SERVICE BULLETIN

TR-9000

#859

SUBJECT: TR-9000 Temperature Stability Improvement

On the PLL unit X50-1620-00 at Q13:

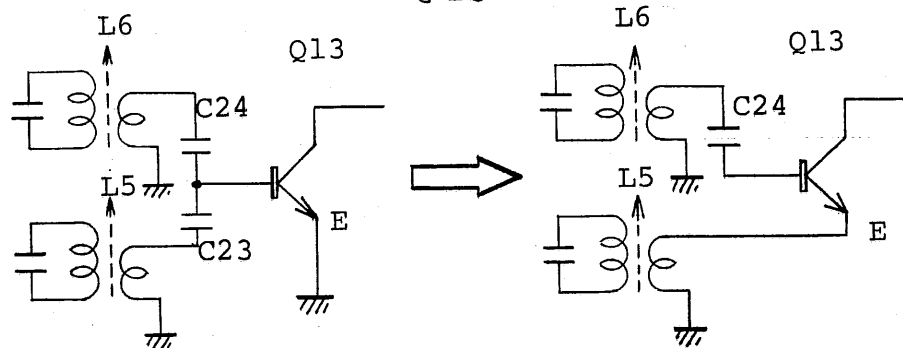
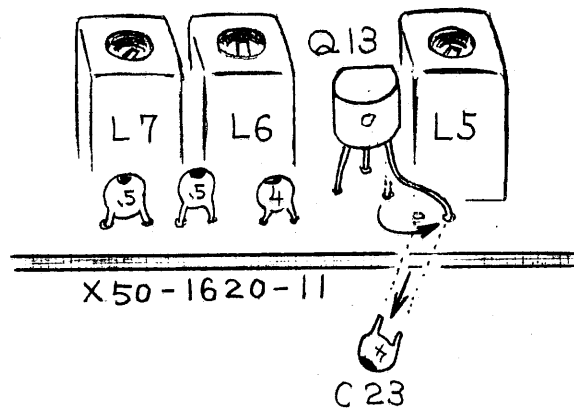
PLL noise or unlock at high temperature may be cured by changing a mixer feed point in the PLL.

Measure TP3 on the PLL unit. If greater than 0.5V RMS signal is available, this change will not be required. If less than this level is present, proceed.

1. Remove and delete C23.
2. Connect Q13 emitter to L5 "hot" (original C23 take-off.)
3. Realign L5, 6, 7 for at least 0.5V RMS at TP3.

Alignment Note: To align L6 & 7, first position the slugs flush with the tops of the coils, then alternately adjust these two coils for maximum output at the first peak into the coil (fundamental frequency). Then align L5 for maximum.
